Rosefield Solar Farm

Applicant's Response to Action Point 45
from ISH1
(Tracked)

EN010158/APP/8.26 2

Revision 021

Figure 1- Plan showing the fields investigated for Exposure Levels

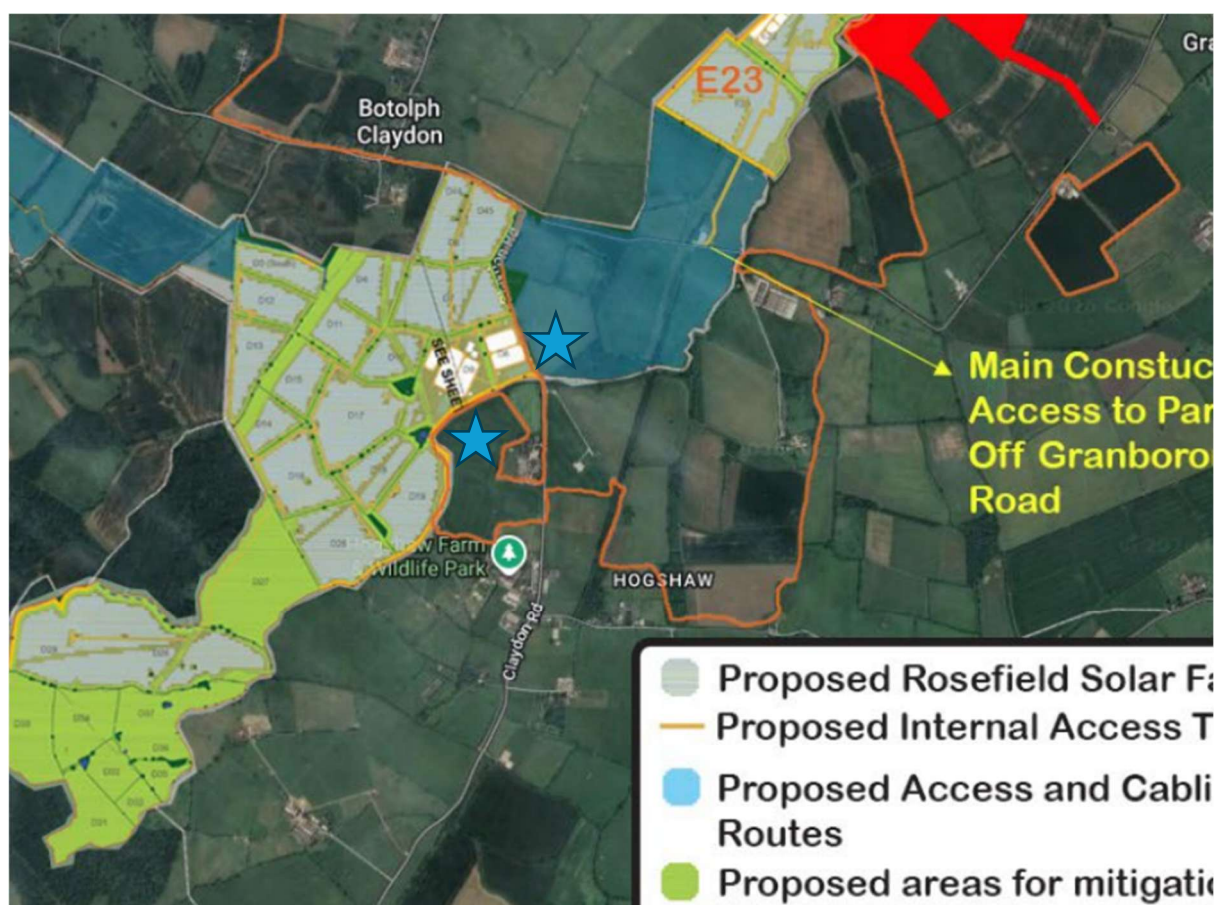
- 3.1.1. Due to the concerns raised by TCS Biosciences/Preston Farms in their written submissions to Examination, the Applicant has further investigated emission levels in the fields closest to the BESS where horses and livestock from the TCS Biosciences/Preston Farms could be located. Figure 1 shows the closest fields in the Preston Land Holdings that are indicated with a blue star. Extracted from [REP1-133](#).

Figure 2- 100th Percentile 1-hour HF Concentrations (ug/m³)

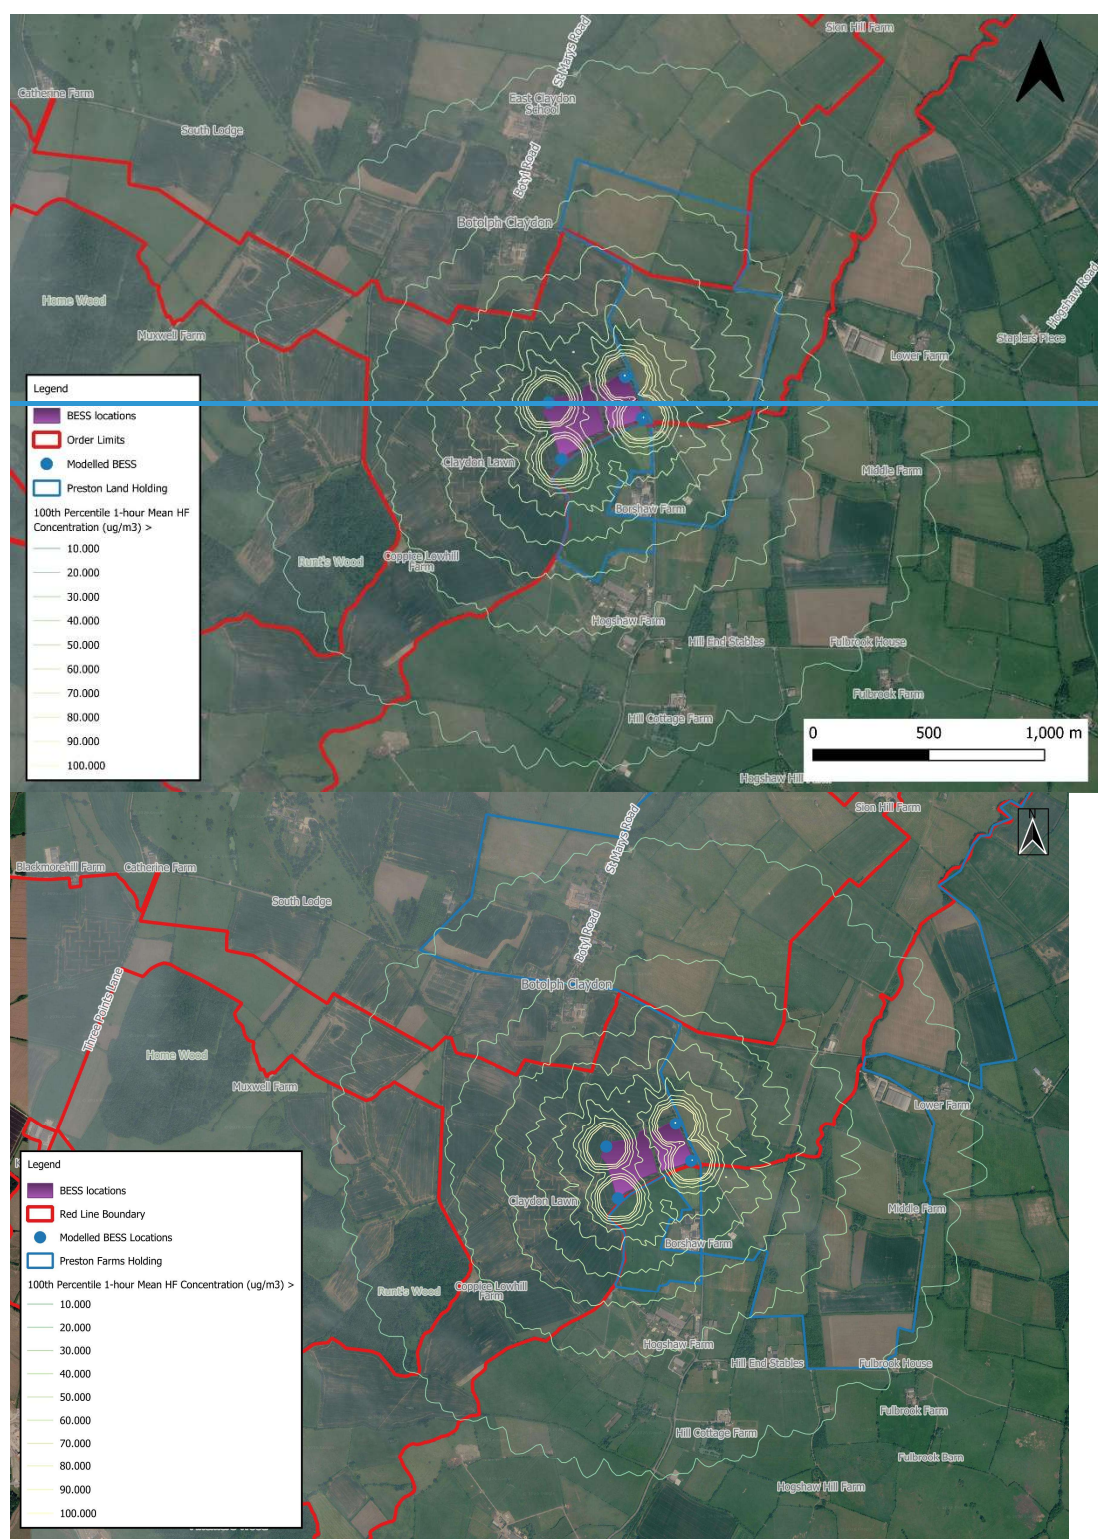
- 3.1.3. Figure 5.1 within the **BESS Plume Assessment Summary [EN010158/APP/7.13.3] [REP3-042]** presents contoured concentrations for the 100th percentile 1-hour hydrogen fluoride (HF) concentrations across the modelling domain, including the entire Preston Farms holdings area. Two additional contours of the 100th percentile 1-hour hydrogen fluoride concentrations in higher resolution around the adjacent TCS Biosciences/Preston Farm fields are also presented for clarity in Figure 2 and Figure 3 of this document.

- 3.1.4. The contours presented in Figure 2 and Figure 3, and in the BESS Plume Assessment Summary, demonstrate that the predicted 1-hour HF impacts during a BESS incident are below the assessed Air Quality Levels (i.e., the US EPA AEGLs), and this is the case across the entire modelled grid (including all Preston's Farm holdings), with no predicted 1-hour concentration exceeding the 1-hour HF AEGL1 of 860 ug/m³.
